17-072FDP – TUTTLE CROSSING MOTEL 6

Proposal

Final Development Plan (FDP) for a three-story hotel and associated site improvements

East Elevation

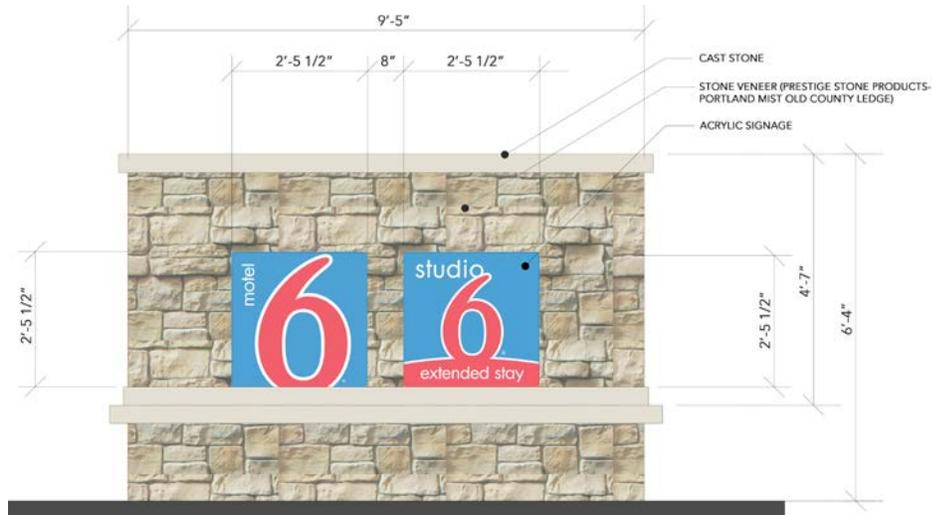
The applicant has further refined the elevations to address the comments presented by the Commission at the September 21, 2017 meeting. The proposed architecture consists of a three-story building in a rectangular shape with a hip style main roof mass and gable roof above the main entrance and accents along the northern and southern masses for both the east and west elevations. The proposed roof has retained the 6/12 pitch and adheres to the maximum height as measured by Code.

The applicant has removed the 'Mahogany' fiber cement accent and replaced those sections with stone and brick veneers. Cultured stone has been extended to the second floor with fiber cement siding used for the center mass as accents to the masonry. The applicant has provided architectural examples of the proposed materials and is adhering to the earth tone palette outlined in the development text. The dumpster enclosure located in the northeast corner will use the proposed stone to complement the principal structure.
